# VALUE ENGINEERING WORKSHOP

## I-85 INTERCHANGE AT CR 98/GABBETTville ROAD PROJECT NO. CSNHS-0008-00(232) Troup County, Georgia

29 September 2006

SECTION 103  
TYPICAL SECTION  
RAISED 20' MEDIAN  
NOT TO SCALE

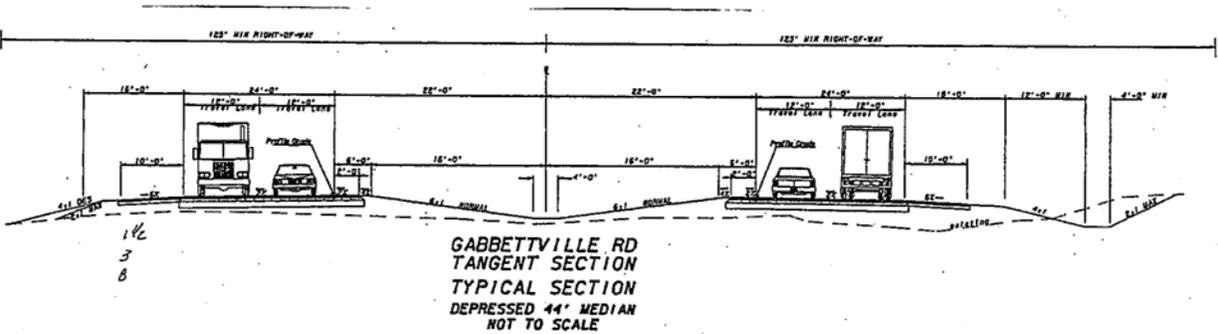
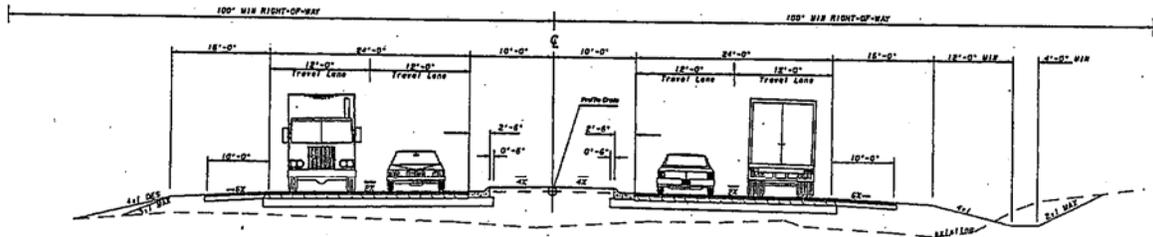
**PROPOSAL DESCRIPTION:** UTILIZE 20' RAISED MEDIAN FOR  
GABBETTVILLE RD.

**ORIGINAL DESIGN:** The original design is a 44' depressed median on Gabbettville Road (1.65 miles)

**PROPOSED CHANGE:** The proposed change recommendation is to reduce the median to a 20' raised median on Gabbettville Road.

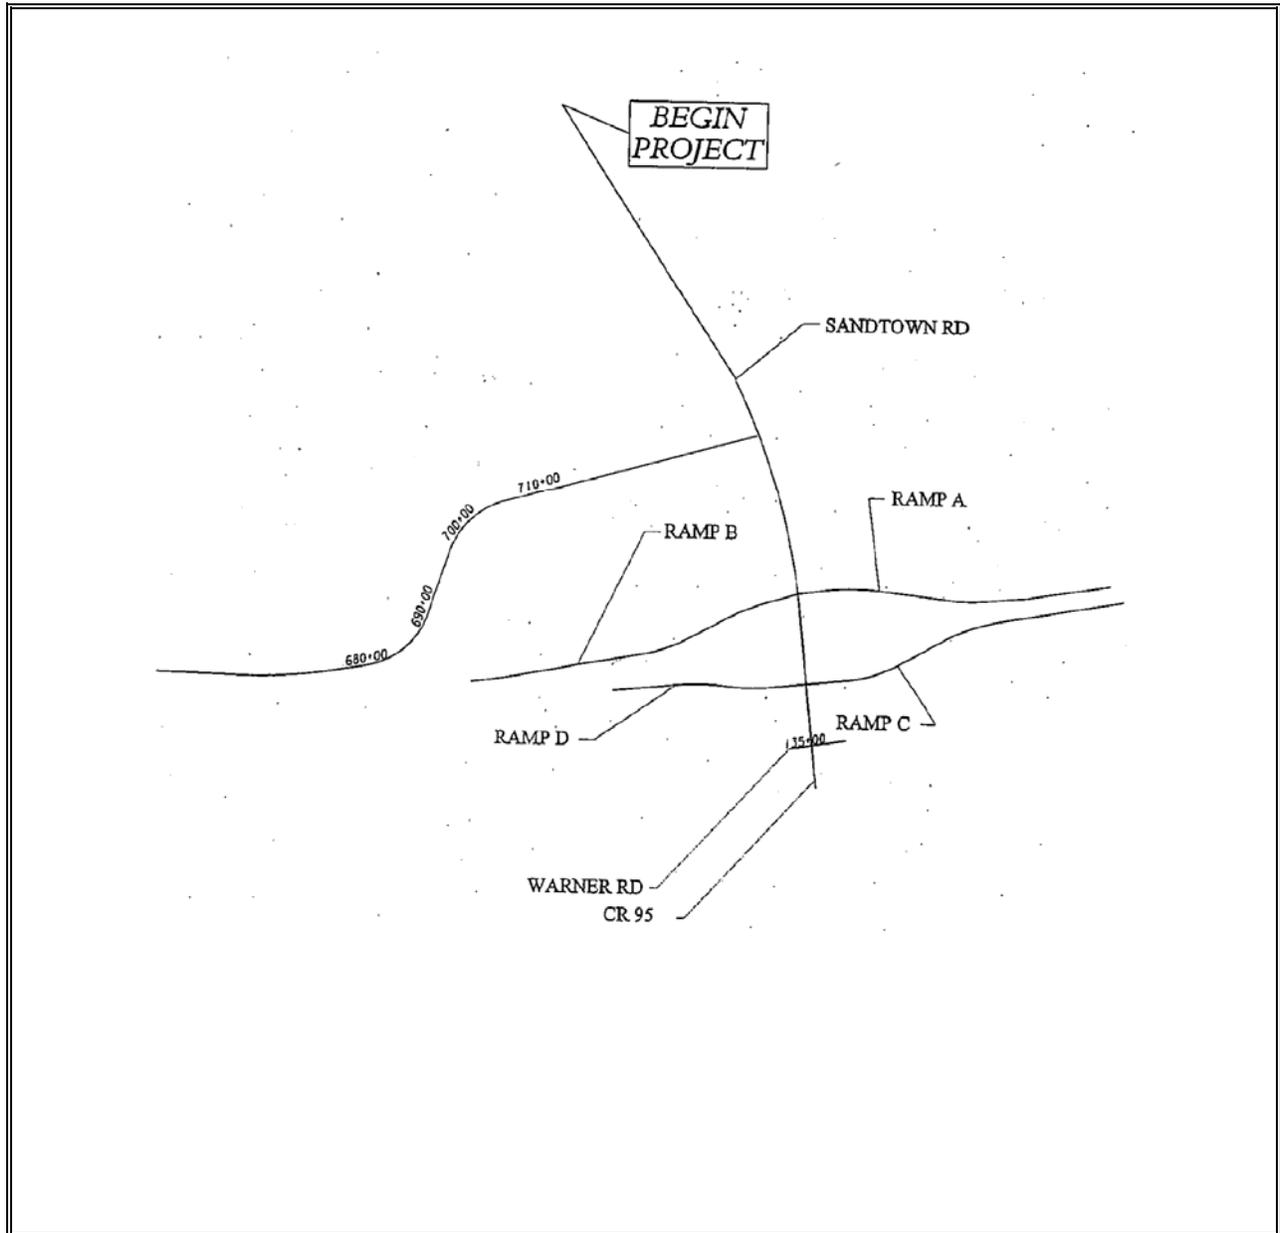
**PROPOSED CHANGE:** The proposed recommendation is for I-85 diamond interchange to be moved approximately 2100 ft . east to tie into a relocated Sandtown Rd.

Reduction in construction and right of way costs due to utilization of Sandtown Rd.

PROPOSAL NUMBER: RW-6.0

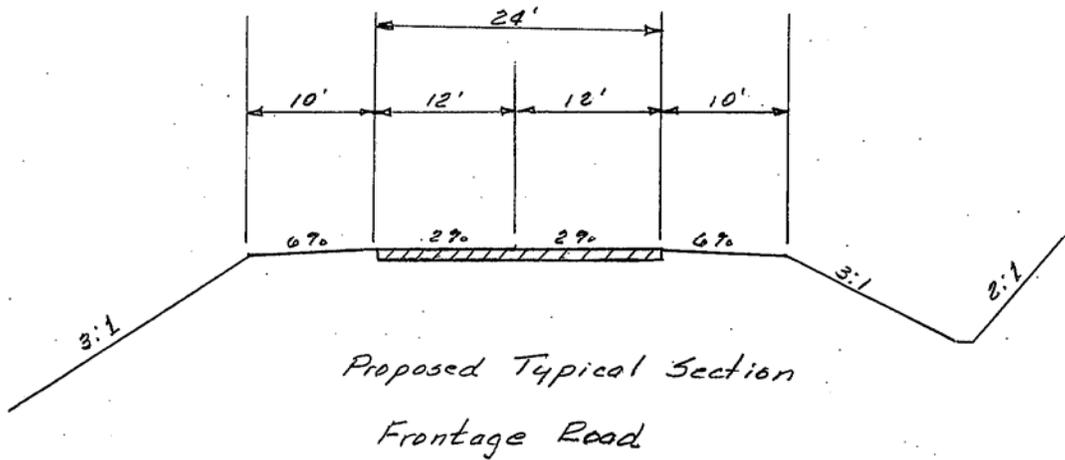
**PROPOSED CHANGE:** The proposed design change recommendation is to construct two lanes of the proposed four lane frontage road with 10 feet shoulders.

**PROPOSAL NUMBER:** RW-6.1

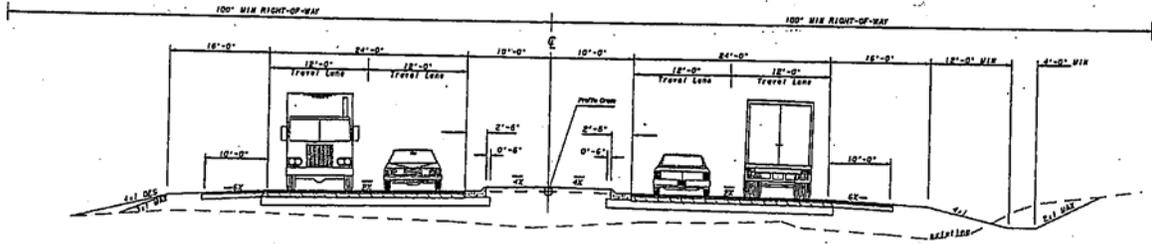
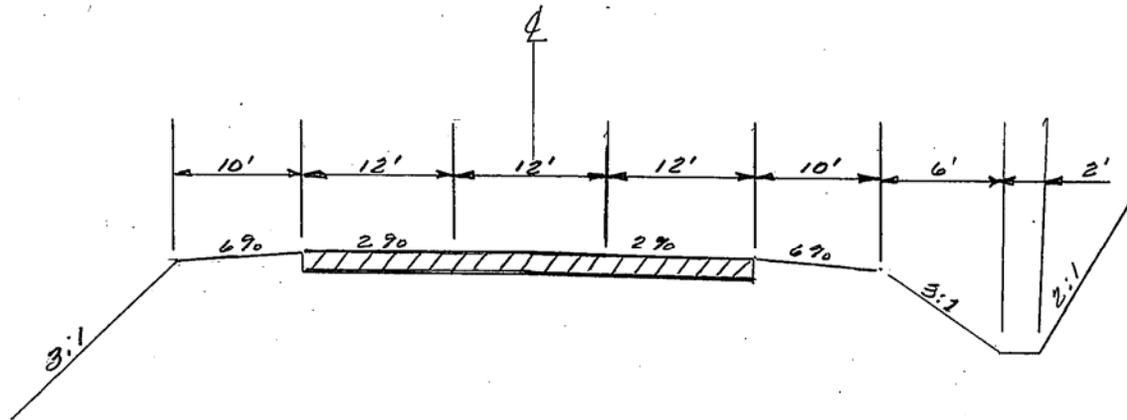
**PROPOSED CHANGE:** The proposed design change recommendation is to construct a three lane flush median roadway with 10 feet shoulders.

**PROPOSAL NUMBER:** RW-6.2

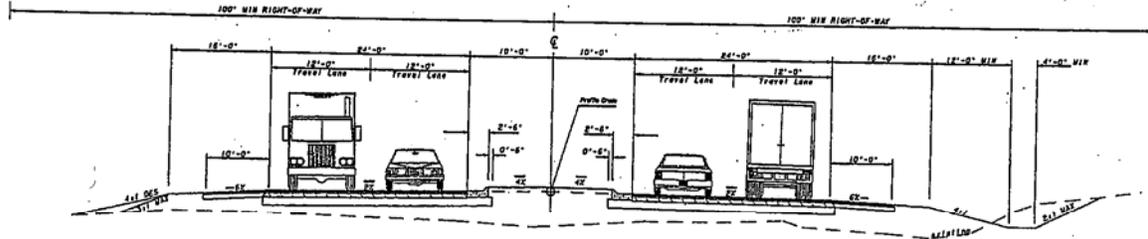
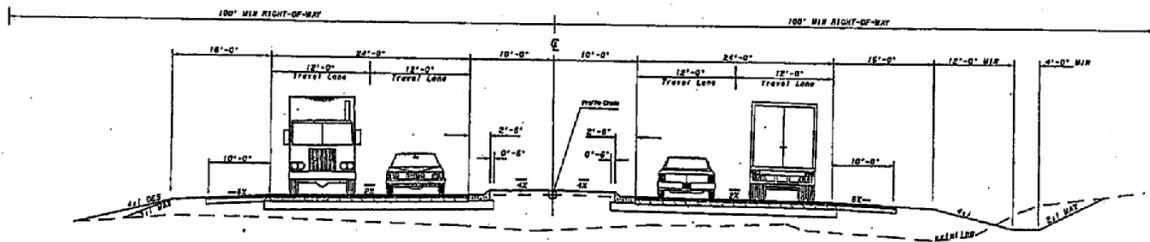
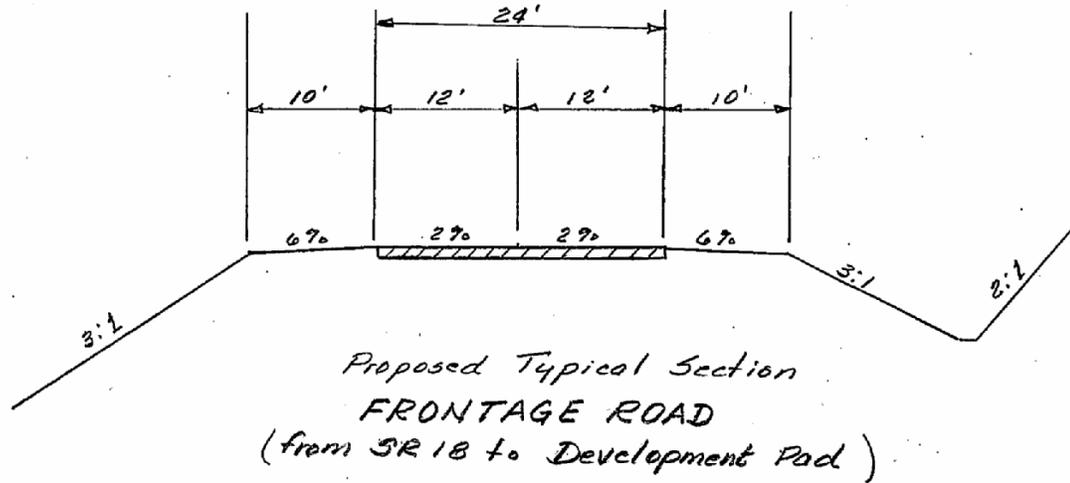
**PROPOSED CHANGE:** The proposed design change recommendation is to construct a two lane Frontage Road from SR 18 to the development site and transition to the proposed concept divided four lane facility in front of the development and on to Gabbettville road.

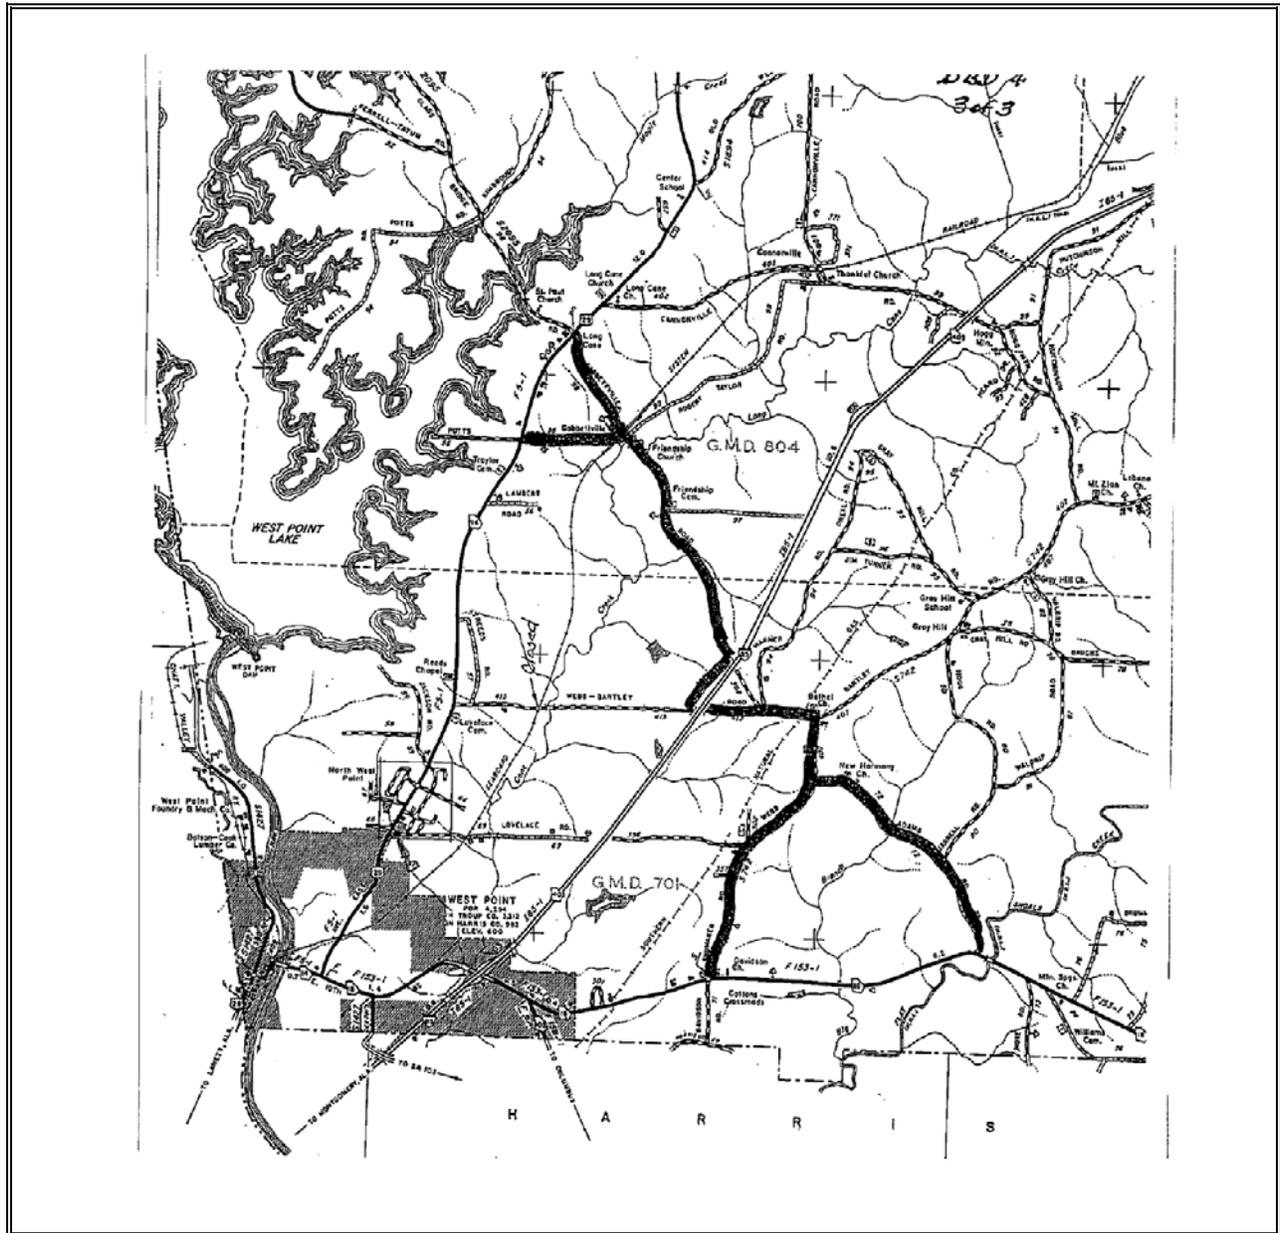
**ORIGINAL DESIGN:** The current documents show access to the site is limited to existing county roads with weight restrictions. Tremendous volumes of loaded construction trucks will damage these roads well beyond both projects.

**PROPOSED CHANGE:** The final RFP design build documents should address who will repair damage to access roads during construction. The document should also provide which roads will be acceptable or if some are to be restricted. If restricted who will sign and enforce restrictions. Troup county will have to be included. Define who will pay for maintenance during construction and maintenance level expected.

DB-4.1

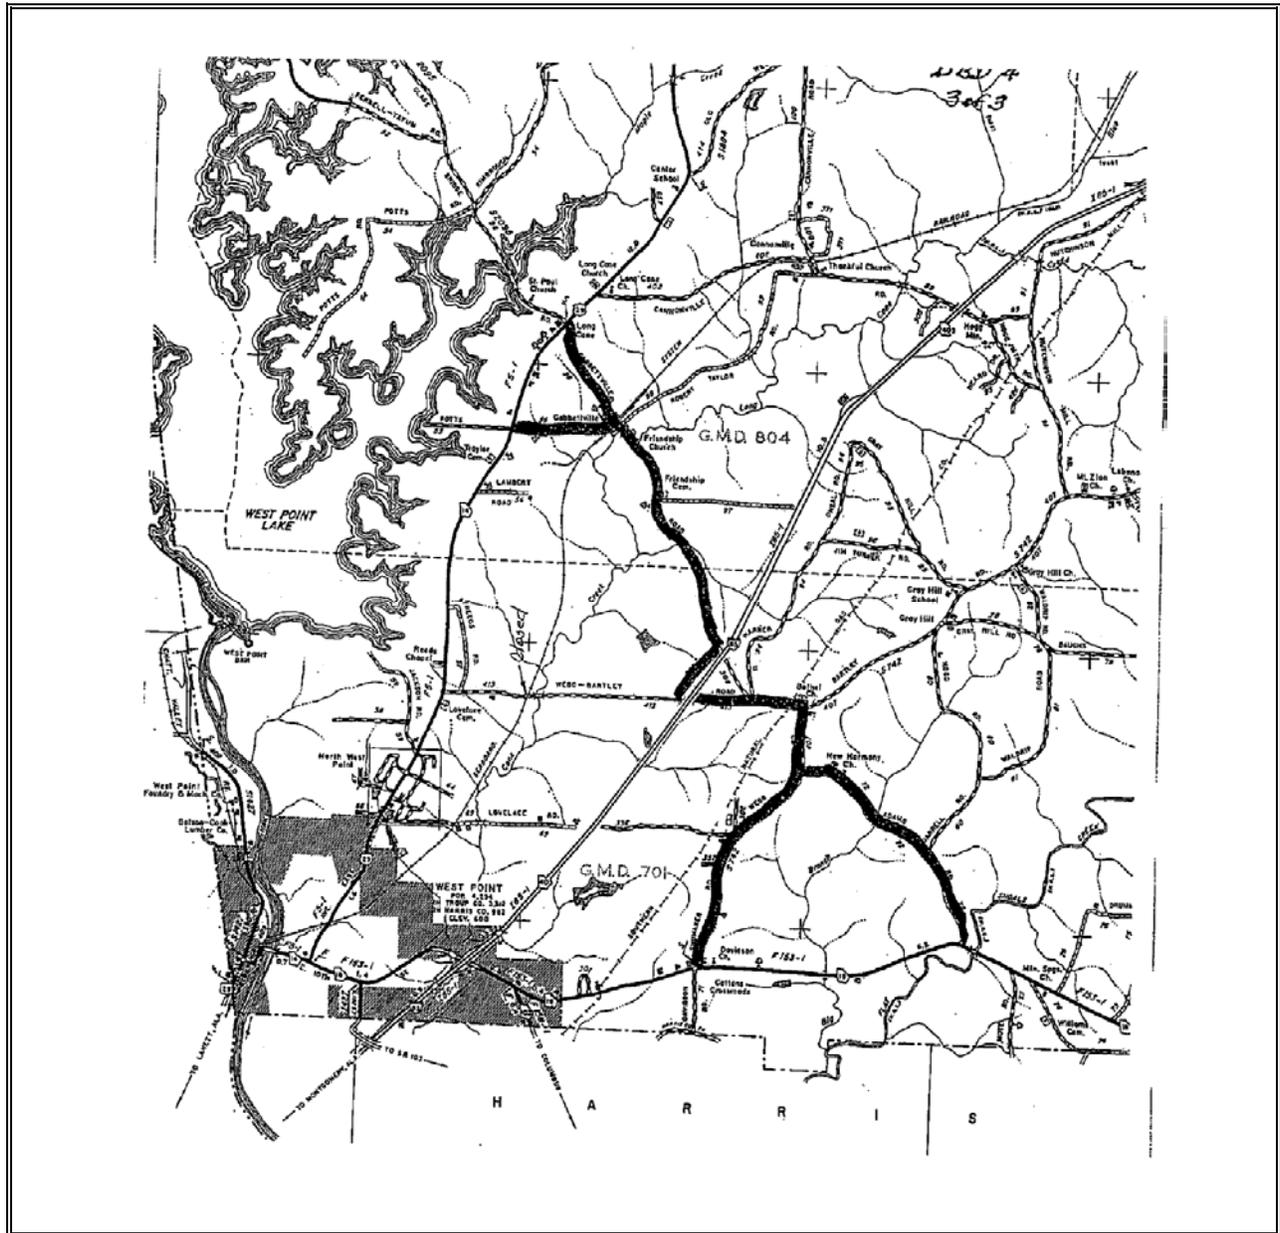
<p><b>ORIGINAL DESIGN:</b> The design/build documents provided does not address restoration of county roads damaged as a result of heavy loads along county roads during construction.</p>
<p><b>PROPOSED CHANGE:</b> The proposed recommendation is to recognize that permanent damage will result from construction traffic on county roads that are not restricted. The proposal is to identify a methodology to restore these roads to an acceptable service level, define that level and determine who pays for the restoration.</p>
